**A POWER QUALITY REVIEW  
FOR  
A Fast Food Restaurant**

**METER-TREATER, INC.**

<p># 3: Utility Transformer</p>	<p># 4: Main Panel Board</p>	<p># 5: 120/240 Panel</p>

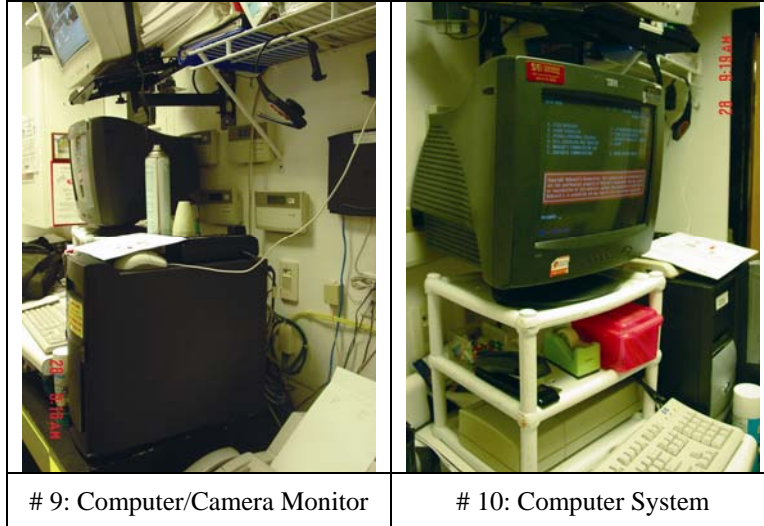
A 300kV transformer supplies ac power to the site (photo # 3). The main facility entrance is a Square D High Line Panelboard, (photo # 4). The main ground rod was not located.

The main ac distribution panel or panelboard is located internally along a wall in the restaurant (photo# 4). Panelboard ratings are 1kA for 277/480 volt 3phase service.

The second panel (photo # 5) is rated as a 125 Amp 120/240Volt, Split Phase Wye device. This panel, labeled for computer use, appears to service the office-networked equipment (photos #6 – 10).

No power protection was located anywhere within the facility, however there was a UPS system attached to the computer.

Install a Hardwire Surge Protection Device, suitable for service entrance locations, on the main AC Panel (Model RCHW, MST, BPT or MPT).

Install additional Surge Protection Devices on each of the two sub-panels (Model RCHW, MST or BPT).

<p># 6: Cat5</p>	<p># 7: Muzak</p>	<p># 8: Telephony (Modems)</p>

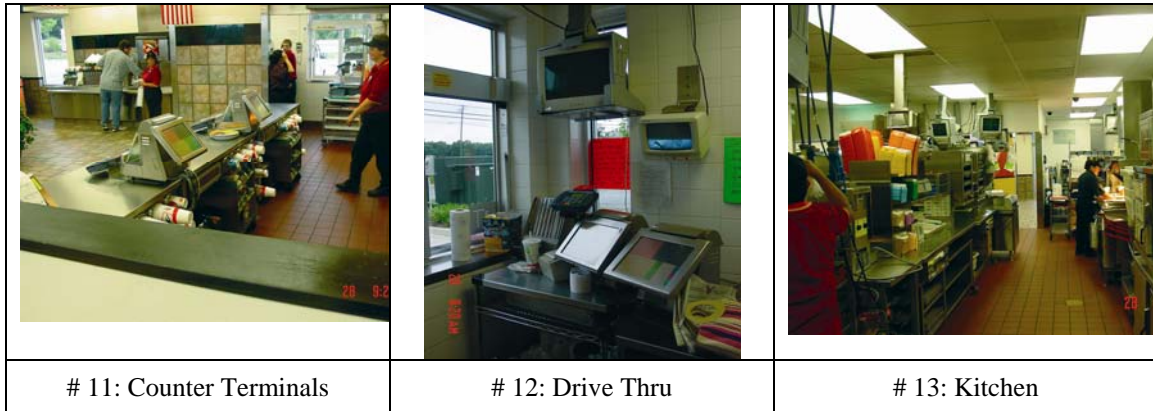
- a. Primary (incoming) Lines: The telephony demark is located next to the main ac panel board and has primary protection in place (see photo # 4); however; there is no evidence of any secondary protection for modems and like equipment.

2. **Video/Security/Sound System:** The video monitor/recording system is not properly bonded to the facility ground and it is not protected from surge voltages. According to on site personnel the equipment had received damage from the last storm/surge event. The security/alarm system was not reviewed (see photo #6).
3. **Computer:** The computer located in the office is critical to daily operations. It must be able to communicate with the outside world via its modems. It is provided with a UPS backup system but there is no protection evident on the modem interface.

It would be prudent to place point-of-use surge protective devices on all pos terminals, drink machines and any other sensitive equipment. This recommendation is for both the ac power and the data/signal ports (Model TST, HLP and TrippLite SPDs).
